# SERVICE BULLETIN

SB1205

| <b>COACH/BUS MODEL</b>        | : C2045 with wheel chair lift   |
| <b>SUBJECT</b>                | : <b>Lift door latch cover</b>  |

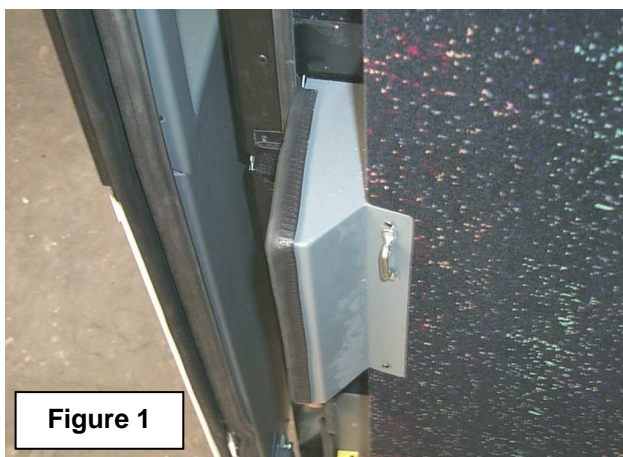
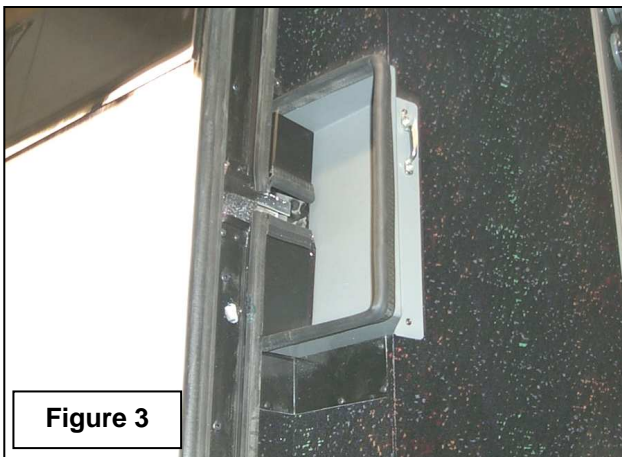
1. On model year 2007 C-coaches the introduction of a convex lavatory entrance door has reduced the upper wheel chair door opening. The smaller clear opening and the required turn to avoid the lift door, the lift door latch cover (Figure 1), and the lavatory have resulted in difficulty of maneuvering into the coach.

2. To address the issue, a new lift door latch cover (Figure 2) has been designed, providing 13/16 inch (21 mm) extra clearance.

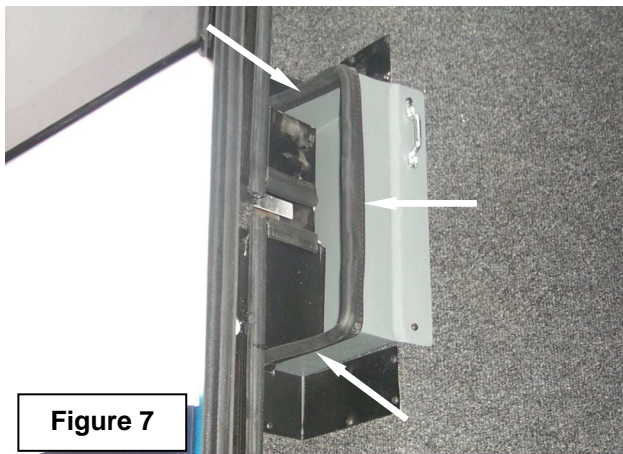
- 3) Using a suitable length of press-fit molding, cover the three edges of the new cover as shown in Figure 7.
